Comments on:

Northwest Energy Coalition's April 2018 Lower Snake River Dams Power Replacement Study

Date: January 20, 2020¹
To: Northwest RiverPartners
From: EnergyGPS Consulting, LLC (“EGPSC”)
Re: Review of the Northwest Energy Coalition’s Lower Snake River Dams Power Replacement Study

Figure 2. NWEC Study GHG Policy Portfolios and EGPSC Indicative Feasible Portfolio (left scale is annual cost, \$millions; right scale is cost per unit of replaced energy, \$/MWh)

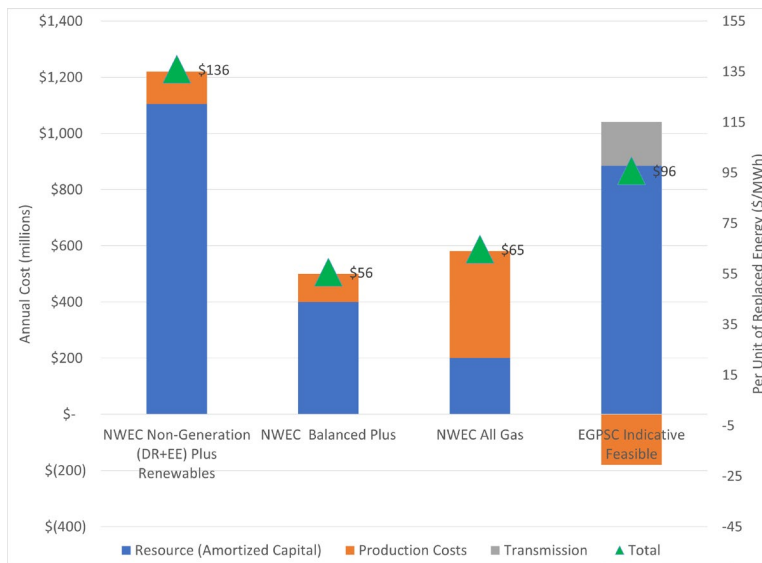
Using this straightforward measure, the NWEC Study portfolios cost between \$56 - \$136/MWh (Figure 2).²³

On balance, the NWEC Study portfolios are either infeasible or significantly underestimate costs. EGPSC estimates that the cost of replacing LSRD with feasible resources is on the order of \$860 million/year or \$96/MWh. As an alternative to NWEC’s results, EGPSC developed a portfolio that is feasible and does not compromise regional reliability. EGPSC calls this portfolio “Indicative Feasible” (Figure 2, rightmost column). This portfolio relies on grid-scale battery storage and renewable power to supply the capacity and energy shortfall created by LSRD’s removal.²⁴ As noted above, also It includes an adder for transmission costs and includes a price on incremental carbon emissions that NWEC only included in its GHG Policy Scenarios. In EGPSC’s view, this Indicative Feasible portfolio is more representative of the cost of replacing LSRD than the NWEC Study balanced portfolio. This cost estimate is approximate and EGPSC’s analysis is not meant to be a substitute for more detailed modeling that should be performed in the future.

Figure 5 NWECC Study GHG Policy Portfolios and EGPC Indicative Feasible Portfolio (left scale is annual cost, \$millions; right scale is cost per unit of replaced energy, \$/MWh)

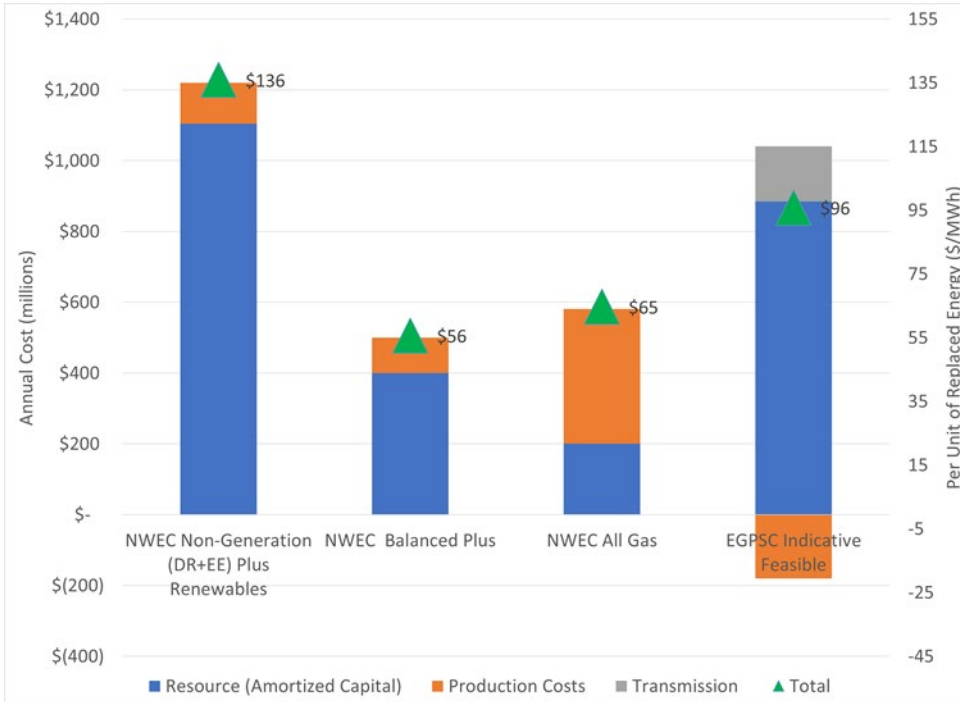
Details of the Indicative Alternative portfolio in comparison to the NWECC portfolios are shown in Table 2.⁴⁷ Figure 5 shows the overall portfolio costs using a presentation form similar to the one made in Figure 14 of the NWECC Study. All the NWECC GHG Policy Portfolios are shown and the Indicative Alternative portfolio is added in the rightmost column. With Figure 5, few key things become readily apparent:

- None of the portfolios are cheap. When it came to costs, the NWECC study focused on indicative bill impacts. Such a measure, however, greatly dilutes percentage impacts because bills include many non-wholesale power cost components, such as distribution costs. EGPSC believes a simpler and more meaningful way to show results is per-MWh-of-replaced-power. By this straightforward measure, all of the portfolios have a cost of replacement power of \$55/MWh or greater.

- The Indicative Alternative portfolio cost is \$860 million/year or approximately \$96/MWh for the replacement power. This is approximately 80% greater than the cost of NWECC Study “balanced” portfolio. The Indicative Alternative scenario does not increase reliance on imports. In fact, it produces an increment of excess energy which can be sold in the regional market. (This revenues from sale of portfolio excess energy is shown in the figure as the “negative” orange bar.) This cost estimate is approximate and EGPSC’s analysis is not meant to be a substitute for more detailed modeling that should be performed in the future.
